**Re: Jackson Hydroelectric Project, FERC No. 2157
Side Channel Enhancement Ramp Rate Evaluation Report
License Article 405**

**Side Channel Enhancement
Ramp Rate Evaluation Report
(License Article 405)**

October 2013

Figure 4-10. Thalweg profile, Side Channel 1 Historic Channel.

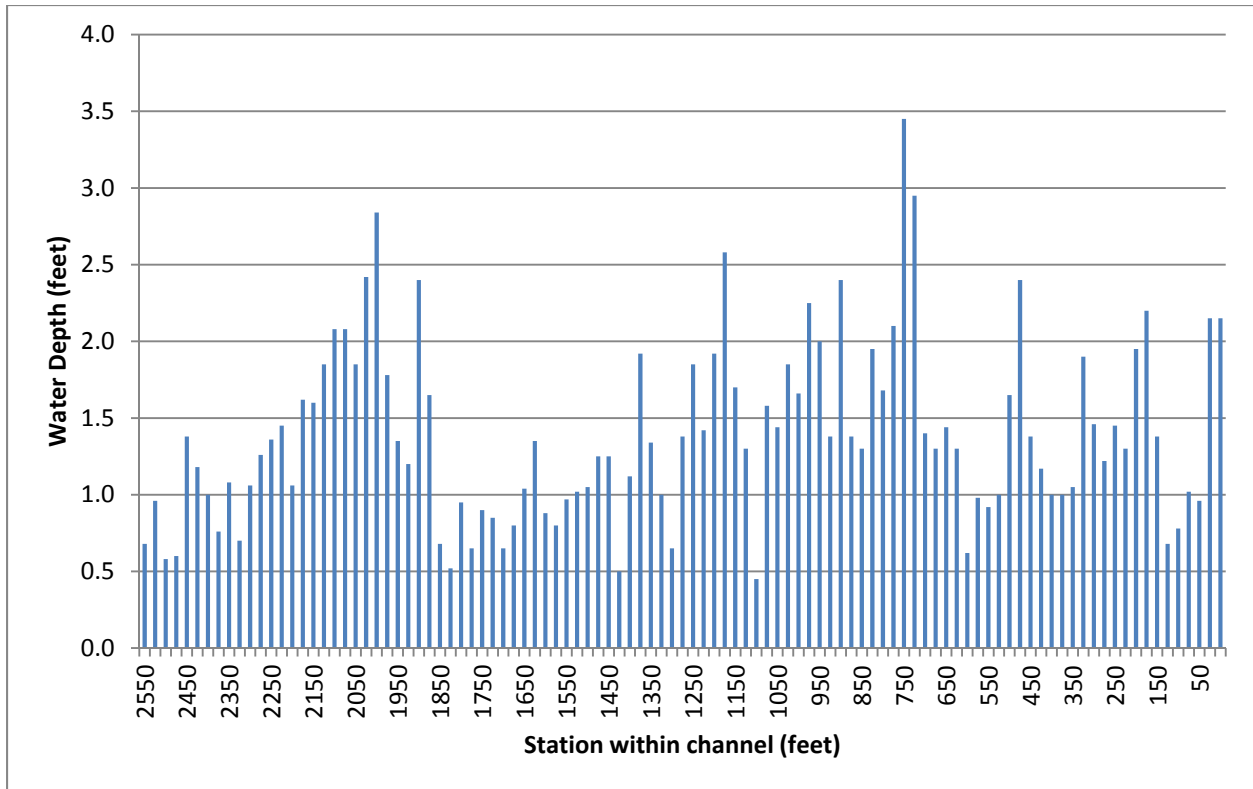
Figure 4-10, page 14. This figure illustrates shallow gravel with little slope. WDFW recommends this area receive additional monitoring and analysis because it would have a higher probability of conventional bar stranding.

16.	Figure 4-10, page 14. This figure illustrates shallow gravel with little slope. WDFW recommends this area receive additional monitoring and analysis because it would have a higher probability of conventional bar stranding.	Comment noted.

**Figure 4-5. Bed and water surface elevations, historic inlet (left side) to SC1, summer 2013.**

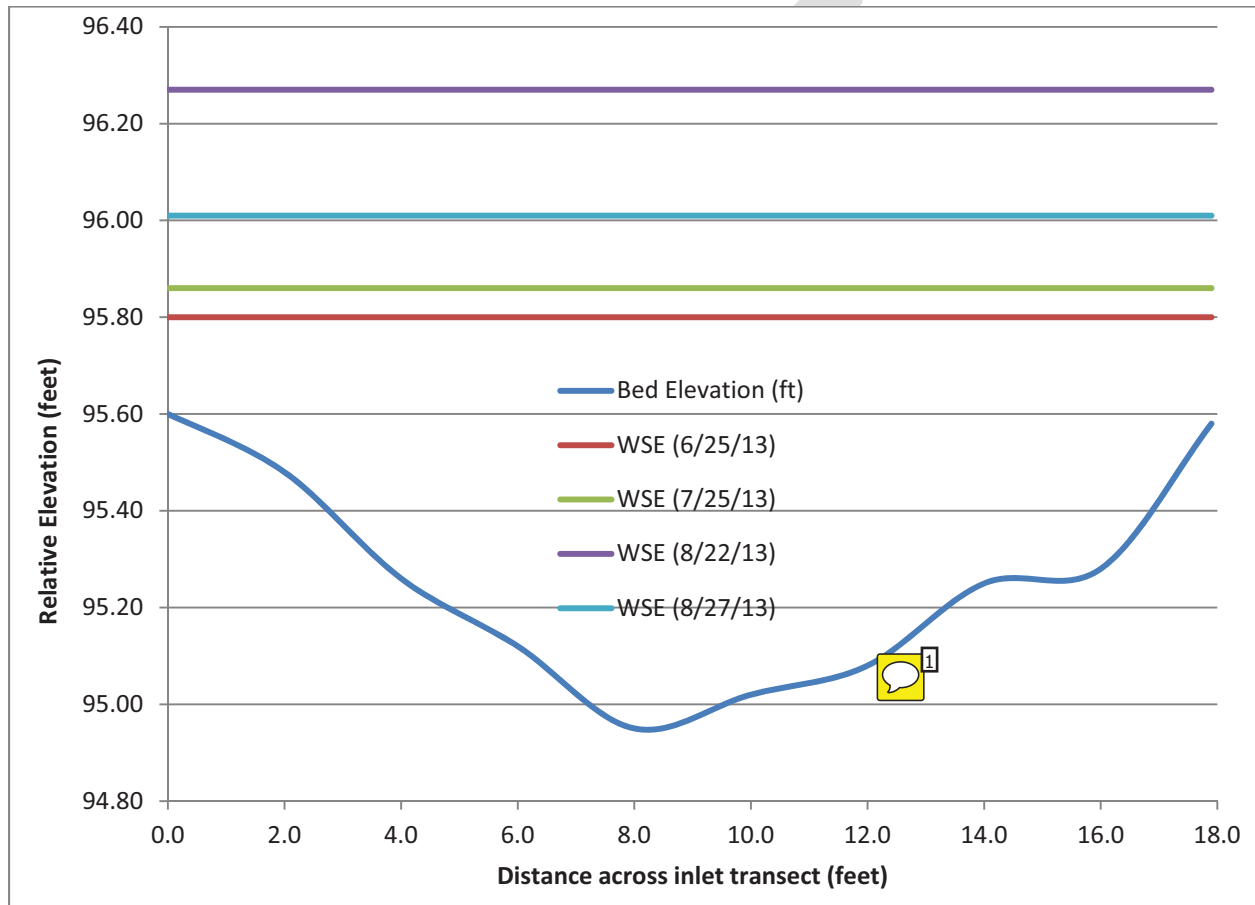
Number: 1 Author: spwfel Subject: Sticky Note Date: 10/17/2013 10:19:19 AM
Seems to me your cross sections should be at existing riffle crest or other flow control feature, not at deepest location next to ELJ?

Hydraulic controls need to be identified within the side channels, at riffles and pool tails, not in the deepest part of the channel. Having flow in the inlet and outlet does not necessarily mean that change in flow is the same within habitat units and margins within the side channel.

Is this survey repeatable?

4.	Figure 4-1: Seems to me your cross sections should be at	See District's Response to Comment 2.

5.	Figure 4-5: This isn't the profile of a hydraulic control point.	Noted and corrected as described in previous comments.
6.	Section 4.2, 1 st paragraph: I'd include more specific reporting of LWD based on the appendix tables? Is wood count only for placed structures?	Refer to District's Response to Comment 3 above. Wood count is for all wood (placed and already existing).

Figure 4-7. Bed and water surface elevations, redundant inlet to SC1, summer 2013.

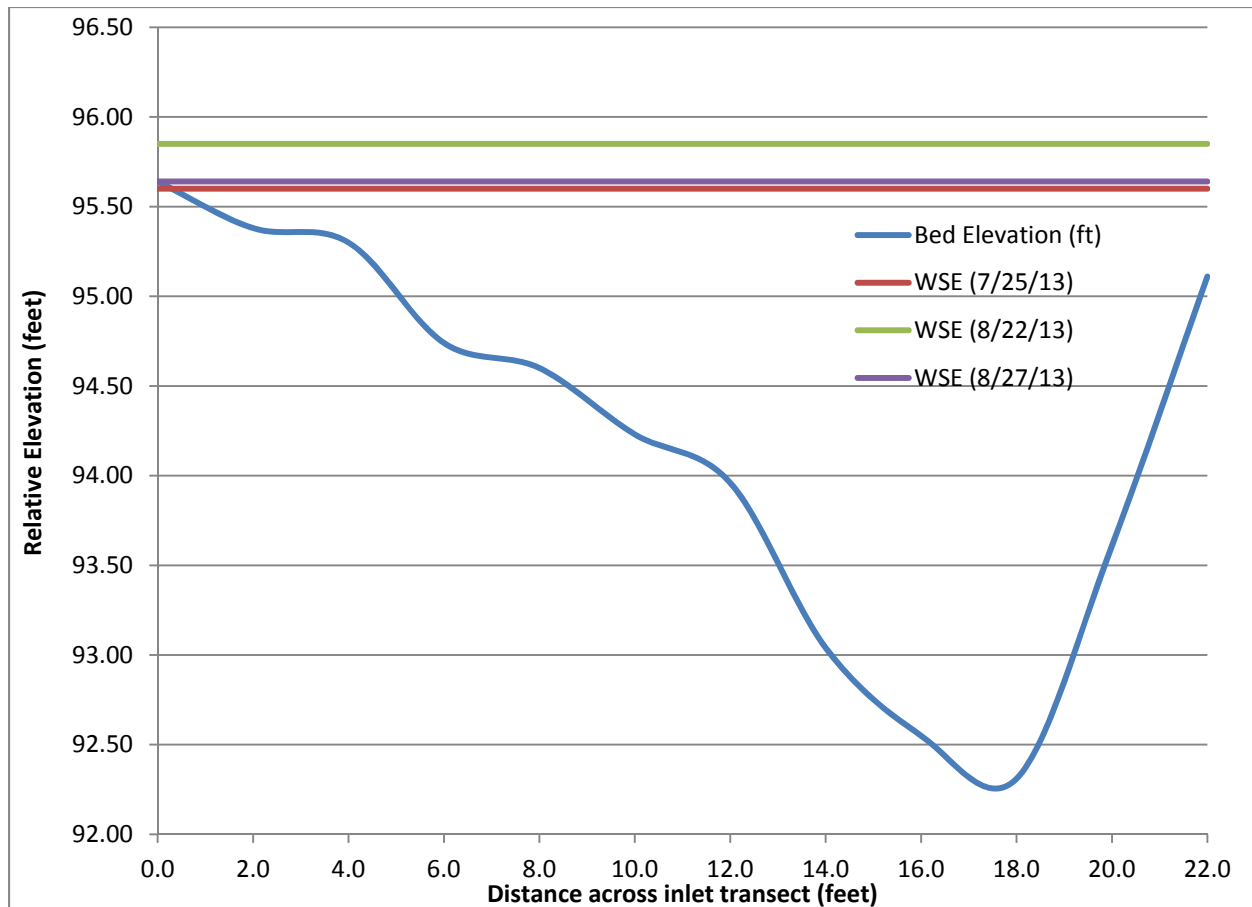
9.	Section 4.1 paragraph under Figure 4.7: was physical habitat identified? Pools, riffles, etc?? It is difficult to tell what the purpose of these measurements were.	These physical measurements were collected during low flow. One set of physical measurements was systematically collected under this low flow to characterize conditions. This information is complemented by photo documentation and engineering survey.
